Product Change Notice (PCN)

PCN Number: PCN-0450024R-01

Product(s) Affected: PJ-075DH-SMT-TR

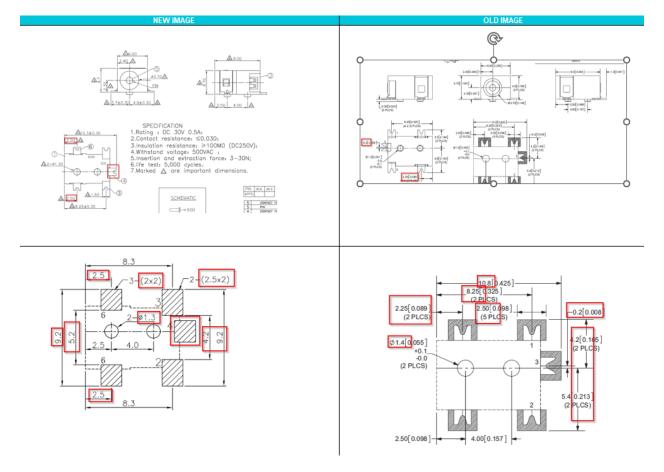
Description of Change: Minor Housing and footprint differences. Material Change on the

housing and terminals. See image Below

Housing and Terminal Material Changes:

Center Pin: Copper to Brass Terminal 2: Copper Alloy to Brass Plastic: PA6T or Equivalent to PA9T
